Application for Licence Amendment

Licence Number	L9195/2019/1
Licence Holder	Kirkalocka Gold SPV Pty Ltd
ACN	626 160 816
File Number	DER2018/001608
Premises	Kirkalocka Gold Mine Part of Mining Lease M59/233 and Mining Lease M59/234 DAGGAR HILLS WA 6638 As defined by the coordinates in Schedule 1: Figure 1 of the Revised Licence
Date of Report	29 September 2021
Proposed Decision	Revised licence granted

Figure 2: UF system layout

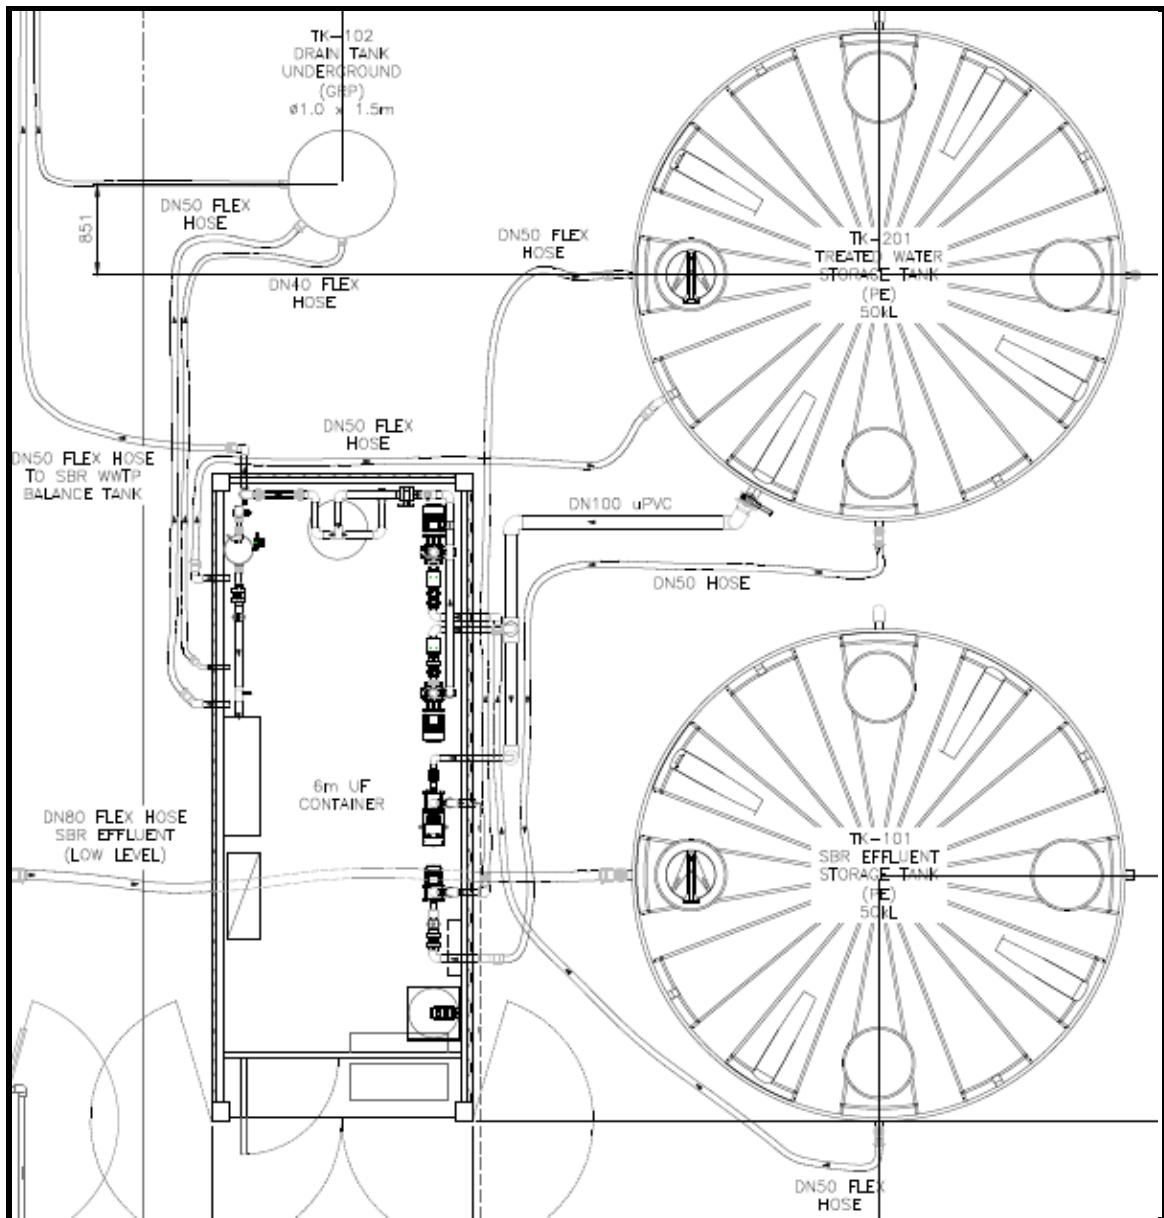
The Licence Holder has identified that during commissioning of the WWTP, the commissioning limits set in the licence were not achieved for all parameters. To achieve compliance with the WWTP discharge Licence limits, the Licence Holder now proposes to install additional tertiary infrastructure known as the 'Tristar tertiary Ultra filtration system' (UF system).

The proposed UF system is located within a 6 m long airconditioned container which is connected to a 50 kiloliter (kL) buffer tank and a 50 kL treated water tank (see Figure 2 below). The buffer tank will be connected to the existing WWTP sequence batch reactor irrigation tank acting as a collection point for the UF system to draw from. The feed pump will draw from the buffer tank and through a multimedia filter installed to filter out any suspended solids greater than 10 microns in size. The wastewater is then feed through a 5 micron rated cartridge to capture further solids prior to entering the UF membrane for a final filtration of the wastewater. The wastewater is then pumped to the 50 kL treated water tank. The treated water will then be circulated through the tank and dosed with sodium hypochlorite before discharge. The system will be fully automated and will be fitted with remote monitoring functions.
